Access Compliance Report

Public Rights-of-Way

Intersection ID: 50467	Main Street: ARSENAL_CT	Cross Street: LENOX_POINTE_DR	Location: SW
ADA ID: 540BF39DDD89	Ramp Type: BlendTrans1	Initial Pass/Fail: Pass	Overall Compliance: No
		Severity Score: 0

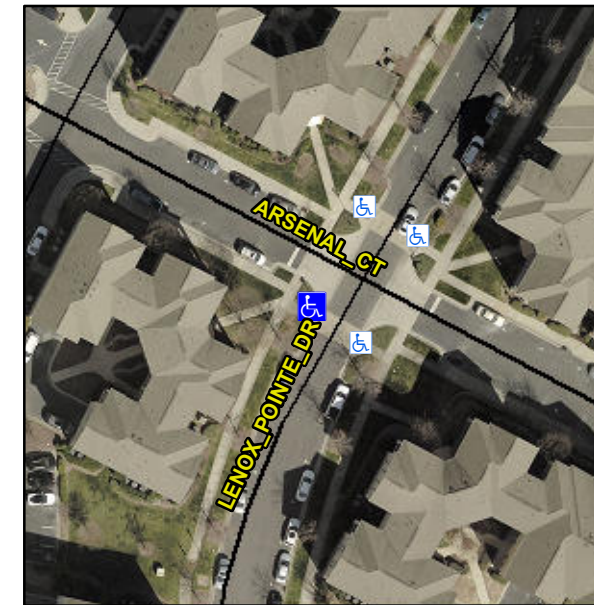
XWALK PAVERS, NO PAINT

Not Found, R304.2.2-Perp, R304.3.2-Para, R305.2

Remove & Replace Curb Ramp With Two New Directional Ramps or Equivalent.
